Rezoning Transportation Analysis

Petition Number: 2021-118

Date	Description
09-23-2021	First Review (KP)

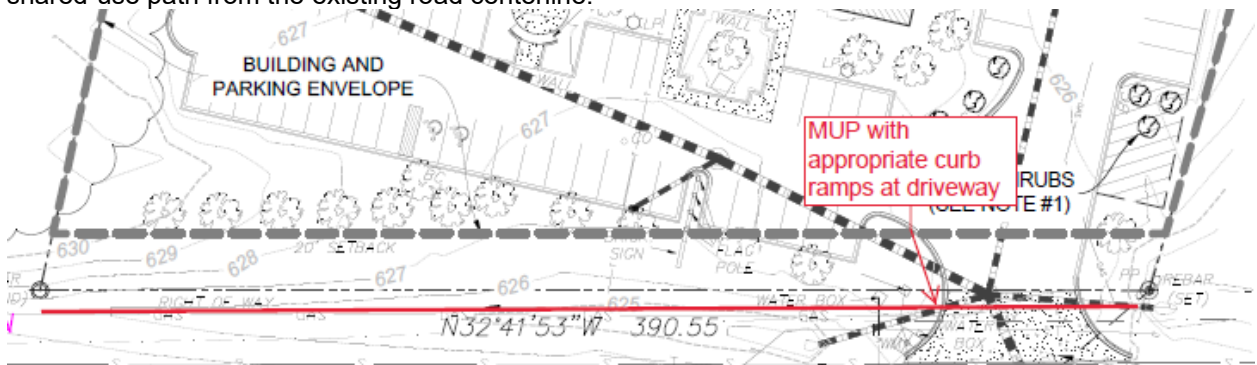
- Curb line:** The proposed zoning district has a setback measured from back of the existing or proposed future curb line.
 - Westinghouse Boulevard:** Curb and gutter is not required with this petition; however, the future location of curb and gutter will be 30-feet from the existing centerline measured to the back-of-curb.

Label and dimension the future back-of-curb from the existing centerline.

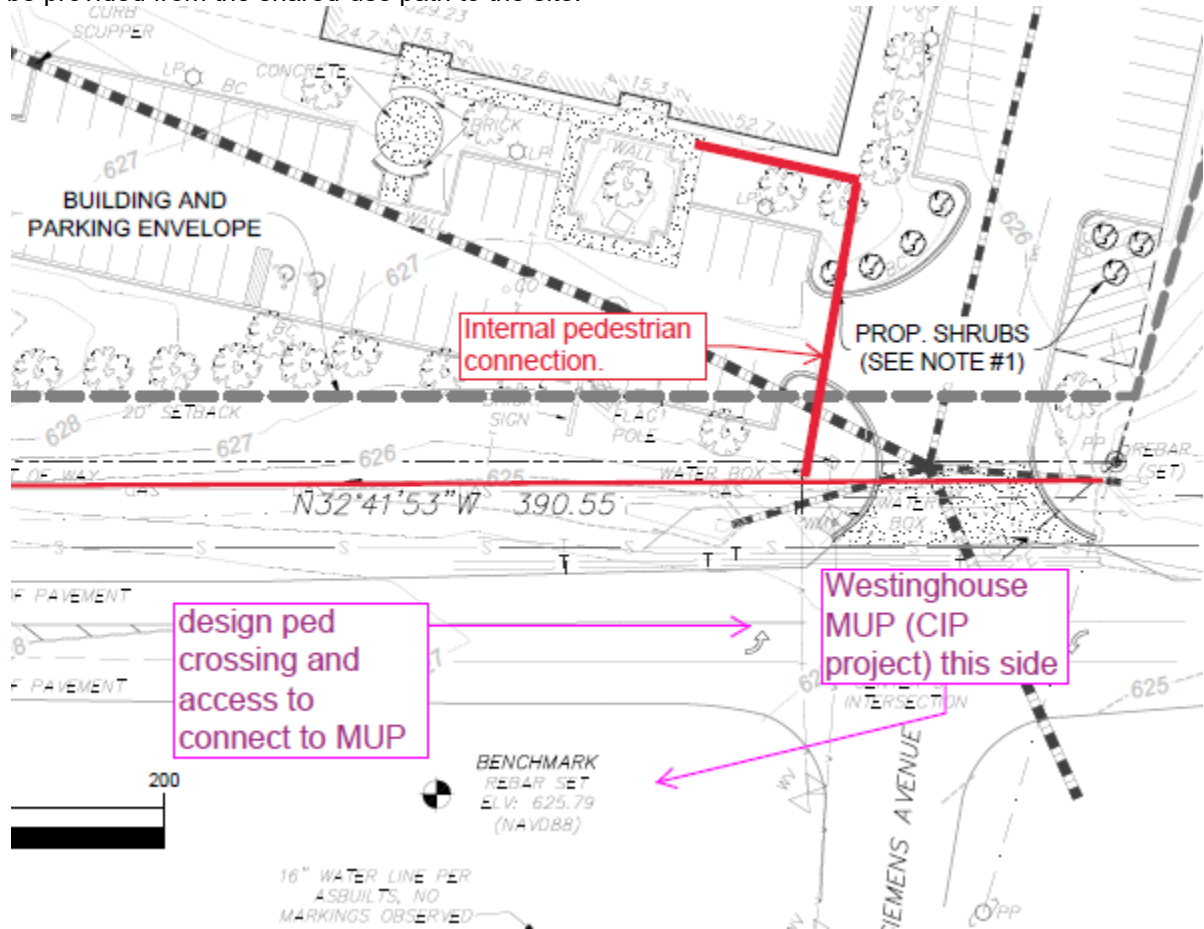
- Revise site plan and conditional note(s) to commit to dedicate 52-feet of right-of-way from the existing centerline of Westinghouse Boulevard. The site plan shall label and dimension the right-of-way from the road centerline.
- Revise site plan and conditional note(s) to commit to construct an 8-foot planting strip, and 12-foot shared-use path along the site's frontage of Westinghouse Boulevard. This shared-use path shall be placed relative to the future curb line location, noted in outstanding issue 1.a, and appropriate ADA curb ramps will be provided across the existing driveway. The site plan shall label and dimension the shared-use path from the existing road centerline.

- Revise site plan and conditional note(s) to commit to coordinating with the City of Charlotte and NCDOT, during permitting, to provide a pedestrian crossing across Westinghouse Boulevard and

provide a connection to the City's Westinghouse Boulevard Multi-use Path Capital Improvement Project. This pedestrian crossing will provide the appropriate curb ramps and components to provide ADA and PROWAG accessibility. Additionally, a direct and logical internal pedestrian connection will be provided from the shared-use path to the site.
